Survey Design Associates Limited
11 Kestrel House, 111 Heath Road,
Twickenham, Middx. TW1 4AF

ProSteel 5.1
What's new ?

Stanchion load entry

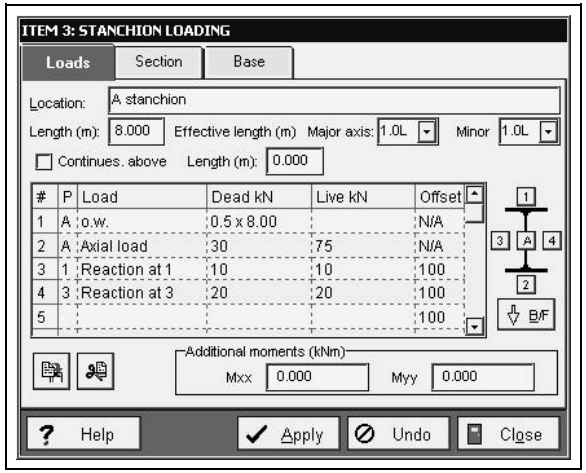
The stanchion load entry method has been completely revised. You now enter loads in a table, much as for beams, and can give loads descriptive names,

The position where the load acts is denoted by 'A' if axial, or '1' - '4' if acting so as to produce a moment. In the latter cases you now have to enter the distance from the face of the member to the position where the load is assumed to act - generally this will be '0' for cap connections and '100' for beam reactions (the cell background will turn yellow if you enter any other value so as to warn you that a non-standard value has been entered). In such cases, as before, the resulting moment is automatically calculated by the program. You can enter any additional moments in the fields provided.
